CITY OF COOS BAY SPECIAL URBAN RENEWAL AGENCY MEETING NOTICE

CITY OF COOS BAY URBAN RENEWAL AGENCY
Agenda Staff Report

ISSUE Review of the Façade Grant for Jon and Patricia Webster

Façade Improvement Grant – 165 South 5th Street

Revised Design

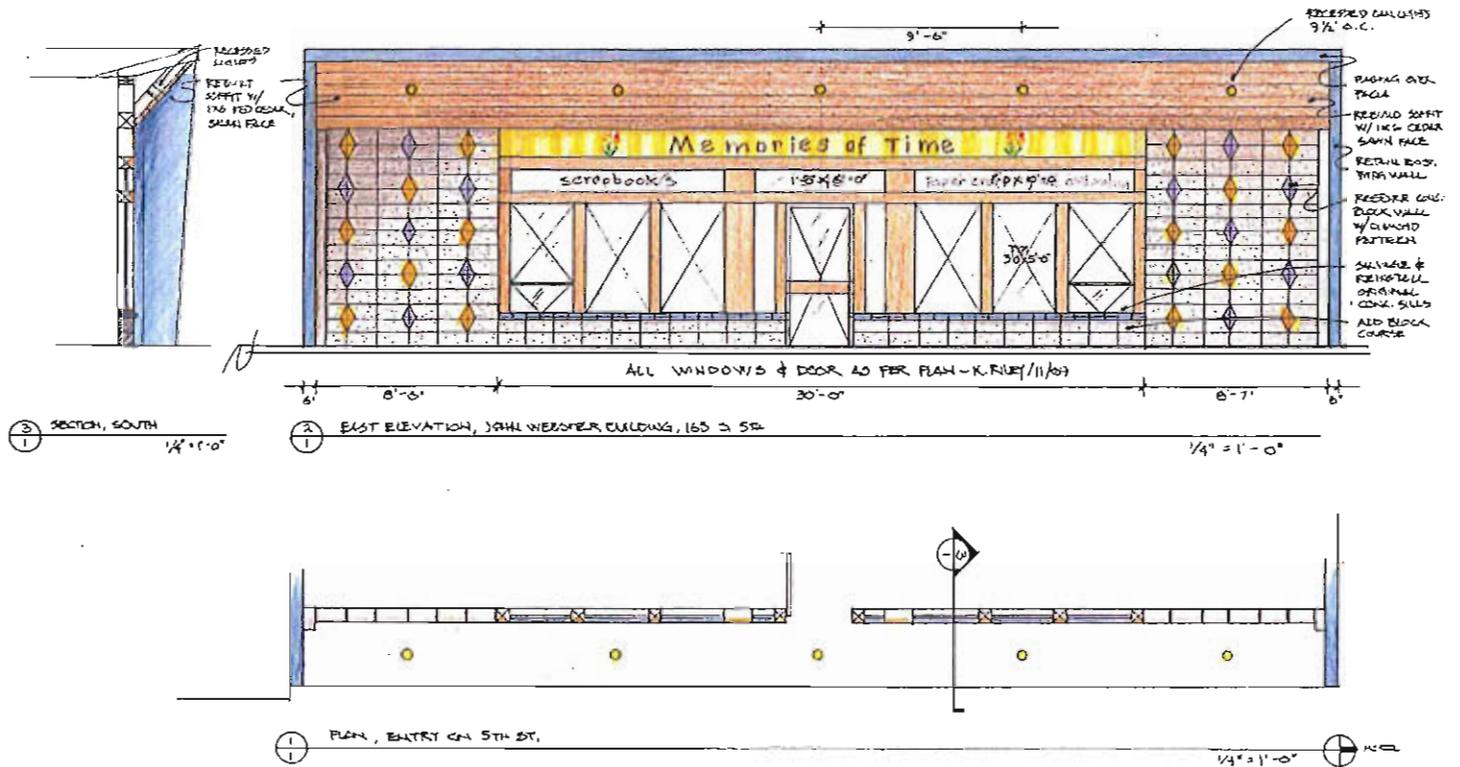
Laura Barron asked if there will be two color options. Mr. Vaughan stated the block wall will remain bare concrete with paint in the diamonds or the grey color of the abutting building with painted diamonds. He said they don't know until they expose the block. If they run into problems (like they can't get paint out of the texture or mortar joints are compromised), they will just paint the block the grey color of the abutting building with the blue of the trim being one of the diamonds colors.

Andy Locati asked about the soffit lights. He asked if the lights can be angled to focus the light on the façade and the ground in front of the business. Mr. Vaughan stated swivels on a gimbal can be installed to help focus the light.

Mr. Locati stated the proposed sign area would be enhanced if the Red Cedar trim would be extended to include the signage area. Mr. Vaughan stated he agrees it would look good and he thinks it is possible.

- MOTION:** Hilary Baker – Recommend the City Council approved the proposed façade improvements as submitted in the April 5, 2012 renderings submitted by Mike Vaughan and the DRC will review the proposed color scheme once the applicants have exposed the original block color.
- SECOND:** Ariann Lyons
- VOTE:** Unanimous
